Community appraisal
on the proposal to discharge of treated effluent from
Narora STP to Talwar Rajwaha

A report on –
joint visit of SSU & HSS : Sept. 21-23, 2019

Submitted to –
The Project Director,
State Mission for Clean Ganga (SMCG),
Department of Urban Development,
Government of Uttar Pradesh

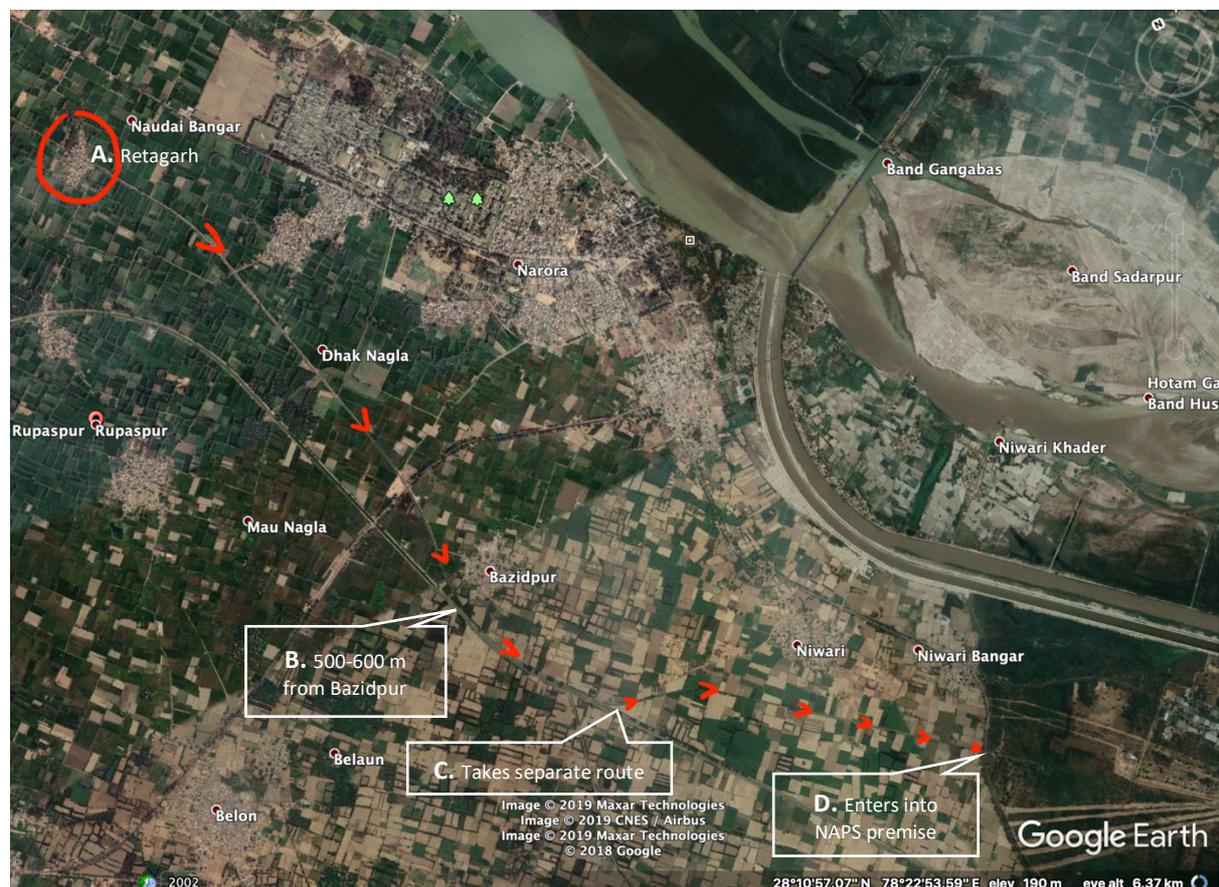
1. The core of the communities' reservation along discharging the treated effluent into the Talwar Rajwaha may be addressed simply by altering the from the proposed site 600 meters up stream to 500-750 meters upstream. The Rajwaha passes through the settlement and indeed does not carry water for a long time. As per the community, the nearly 100 years old Rajwaha rarely operate; has lost its water carrying capacity in most of its stretches.
2. The following depiction suggests the change in site of discharge of treated effluent (from site 1 to site 2). The map below also depicts the proposed pipelines to carry the discharge to Retagarh settlement until the *Narora-Anupshahar* road. The trek across the road towards Retagarh is likely to alter with change of site of discharge.

3. The track where the pipelines are proposed to carry the discharge; as has been marked in the above map, are indisputable. However, the contour of the track is undulating and UPJN would certainly consider arrangements to take the treated effluent to the height that it seeks to carry to the point of discharge.
